TSB 08-2-10

4.6L MANUAL TRANSMISSION - SEPARATOR PLATE

BUZZ - BUILT BEFORE 12/13/2007

2005-2008 Mustang

Figure 1

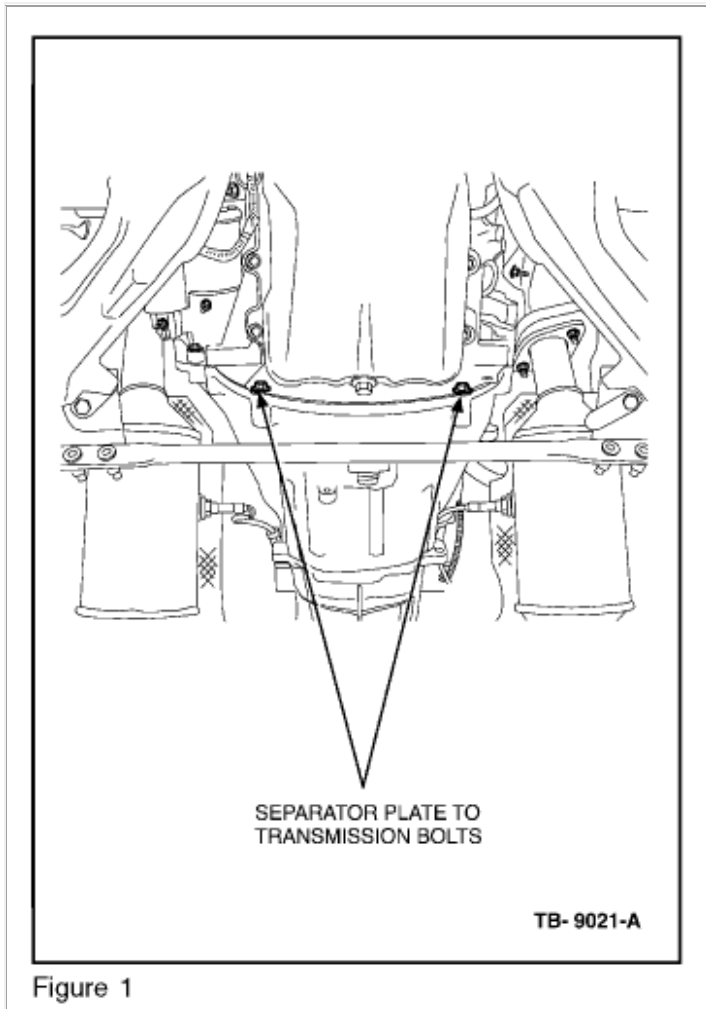
The concern may be caused by the separator plate, between the rear face of the block and the transmission housing, vibrating and/or contacting the flywheel. Follow the Service Procedure steps to correct the condition.

NOTE INSTALL NEW SEPARATOR PLATE TO TRANSMISSION BOLTS IF MISSING OR DAMAGED. (FIGURE 1)

1. Remove transmission per Workshop Manual (WSM), Section 308-03B.
2. Pry separator plate from rear face of block alignment dowels, slide out from between block and flywheel, and replace with new service part.
3. Install transmission per WSM, Section 308-03B.
